CITY OF KELOWNA MEMORANDUM

APPLICATION: DP08-0066 / DVP08-0177

AT: 1520-1550 Union Road

PURPOSE:

Bottom of Sieva Scape Wall

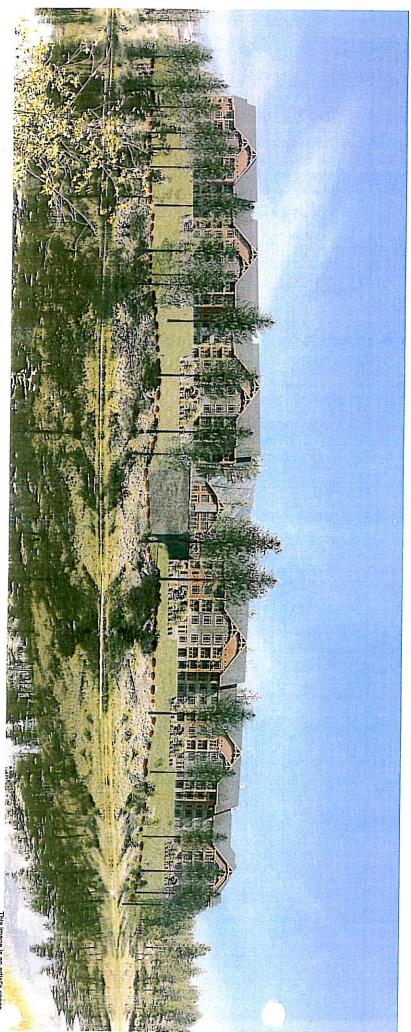
Scape retaining wall is landscaped it will help to reduce the visual impact of the retaining system. However, Staff are concerned with the visual impact that results from the 10m high concrete portion of the wall that is used to support the pool / amenity area.
